**VIRGINIA ELECTRIC AND POWER COMPANY**  
**NORTH ANNA POWER STATION UNITS 1 AND 2**  
**SIX-MONTH STATUS REPORT IN RESPONSE TO MARCH 12, 2012 COMMISSION**  
**ORDER MODIFYING LICENSES WITH REGARD TO REQUIREMENTS FOR**  
**MITIGATION STRATEGIES FOR BEYOND-DESIGN-BASIS EXTERNAL EVENTS**  
**(ORDER NUMBER EA-12-049)**

**Six Month Status Report for the Implementation of Order EA-12-049  
Order Modifying Licenses with Regard to Requirements for Mitigation Strategies for  
Beyond-Design-Basis External Events**

**North Anna Power Station Units 1 and 2  
Virginia Electric and Power Company (Dominion)**

FIGURE 8 (AUGUST 2013 UPDATE)  
120/240 AND 480 VAC  
ELECTRICAL GENERATOR DEPLOYMENT LAYOUT  
NORTH ANNA POWER STATION

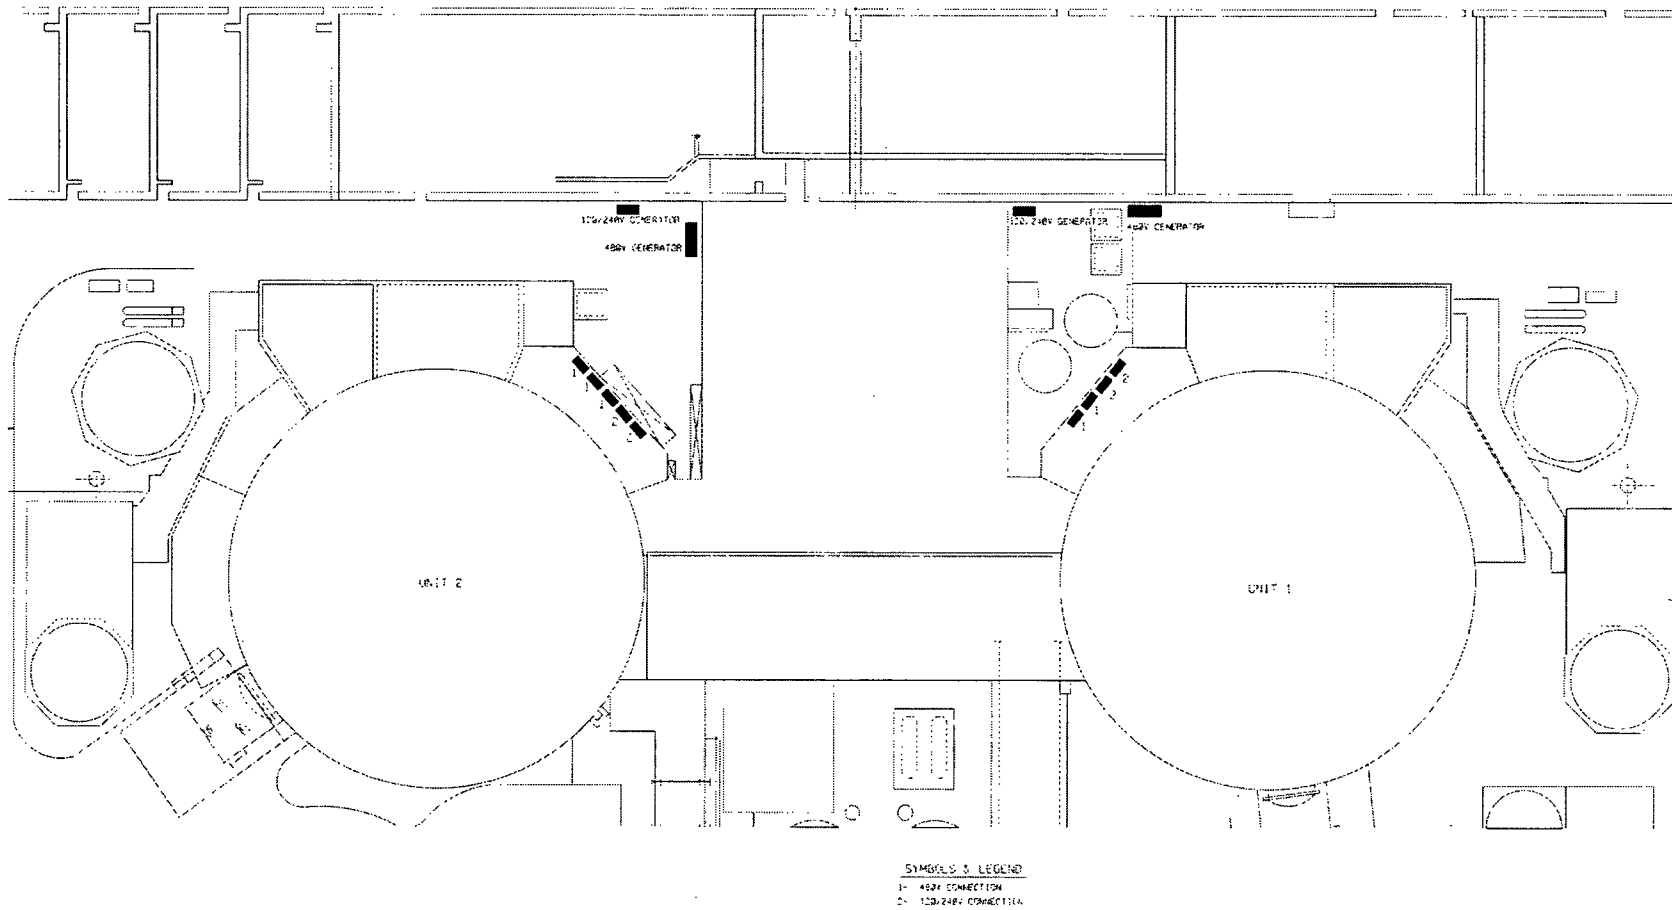
- c) Details of the strategy for the portable diesel generators (DGs) used to re-power the 120VAC vital bus circuits, as described in Section F1.2 – PWR Portable Equipment Phase 2, have changed for North Anna Units 1 and 2. A single 120/240VAC DG per unit will be sized to accommodate the necessary electrical loads for that unit and will power both BDB distribution panels for that unit. Thus, the deployment of two 120/240VAC DGs per unit as shown in Figure 7 of the previously submitted OIP is no longer being pursued, and a revised Figure 7 is attached. Figure 8 is revised to show the location of the single 120/240VAC DG for each unit and the location of the associated unit's connection receptacles and is also attached. Figure 10 was a typical schematic of the connections from one of two 120/240VAC DGs. A revised Figure 10 showing the current connections for the 120/240VAC DG (Unit 1 only) is attached. A spare 120/240VAC DG will be purchased; however, as stated in the OIP, the 480VAC DG is considered the alternate re-powering source for instrumentation.

SEE FIGURE 7B FOR STAGING LOCATIONS OF THE 480V GENERATORS.  
THERE ARE NO TIE INSTALLED RECEIPTILES FOR THE 480V CONNECTIONS.
